5369

**USE, HEIGHT, SETBACK, BUFFER SEPARATION, AND
ACCESS/MANEUVERING SURFACE VARIANCES TO ALLOW THE
CONSTRUCTION OF A 150' MONOPOLE TELECOMMUNICATIONS
TOWER, SETBACK 25' FROM A LEASE PARCEL LINE, SETBACK 25' FROM
RESIDENTIALLY ZONED PROPERTY, WITH A GRAVEL DRIVE AND
PARKING; TELECOMMUNICATIONS TOWERS ARE ALLOWED ONLY IN
COMMERCIAL DISTRICTS WITH PLANNING APPROVAL OR INDUSTRIAL
DISTRICTS BY RIGHT, THE MAXIMUM ALLOWBLE HEIGHT IS 35', A 150'
TOWER MUST BE SETBACK 150' FROM A LEASE PARCEL LINE, A
MINIMUM SEPARATION OF 225' (150% OF THE TOWER HEIGHT) IS
REQUIRED FROM RESIDENTIALLY ZONED PROPERTY, AND
ACCESS/MANEUVERING AREAS FOR TOWERS MUST BE ASPHALT,
CONCRETE, OR AN APPROVED ALTERNATIVE PAVING SURFACE, IN AN
R-1, SINGLE-FAMILY RESIDENTIAL DISTRICT.**

2801 KNOLLWOOD DRIVE

ANALYSIS APPLICATION 5369

SITE PLAN

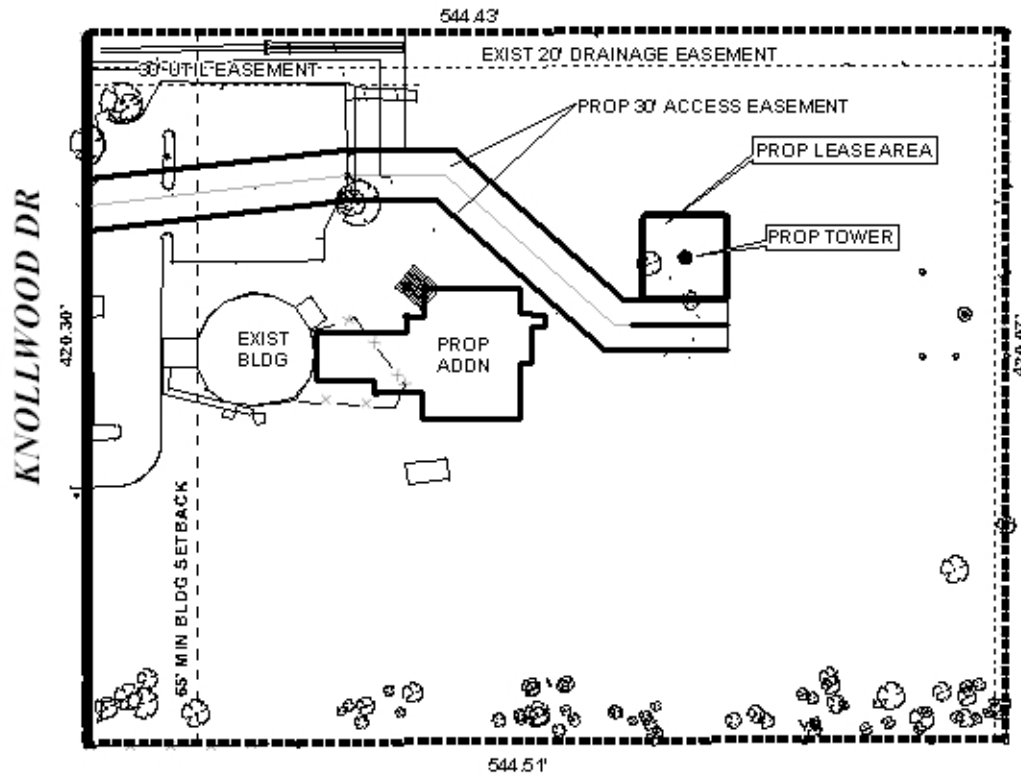
Subsequent to the August Board meeting, the applicant submitted the required affidavit from a radio frequency engineer concerning the lack of other suitable sites within the coverage area, and a network coverage map. However, the site plan is being revised to illustrate an alternative tower location and church facilities, but has not yet been submitted. It is, therefore, recommended that this application be held over in order that the revised site plan can be submitted.

After the September Board meeting, the applicant submitted a revised site plan relocating the tower toward the Northwest; approximately 190 feet West of the rear (East) property line, and approximately 133 feet South of the North property line. The dimensions of the lease compound are still 50 feet by 50 feet. Proposed vehicular access is via a 12-foot wide gravel drive from the middle East edge of the existing parking lot, turning Southeast, and connecting to the South side of the compound. No parking area is shown to be provided for a service vehicle. The new location still requires all variance elements as originally submitted (use, height, setback, buffer separation, and access/maneuvering).

The applicant has already illustrated that there is a hardship in locating other suitable tower sites within the coverage area and has substantially revised the tower location to reduce the impact on neighboring residentially zoned and used properties. However, the applicant failed to illustrate that a literal enforcement of the Ordinance would result in an unnecessary hardship with respect to the gravel access/maneuvering surface variance request. It is simply the applicant's desire to provide a 12' wide drive, without parking, and a gravel surface.

Based upon the preceding, it is recommended that the variances for substandard access/maneuvering and a gravel surface be denied, and that the use, height, setback, and buffer separation requests be approved, subject to the following conditions: (1) the paving of the 12' drive and parking space as required by the Ordinance; (2) full compliance with landscaping and tree planting requirements of the Ordinance for the lease parcel (to be coordinated with and approved by Urban Forestry); (3) full compliance with all municipal codes and ordinances, including, but not limited to, the Telecommunications Towers and Facilities requirements of the Ordinance; (4) that the applicant submit a Certificate of Insurance naming the City of Mobile as an additional insured; and (5) the provision of an engineer's certification regarding the collocation capability of the tower.
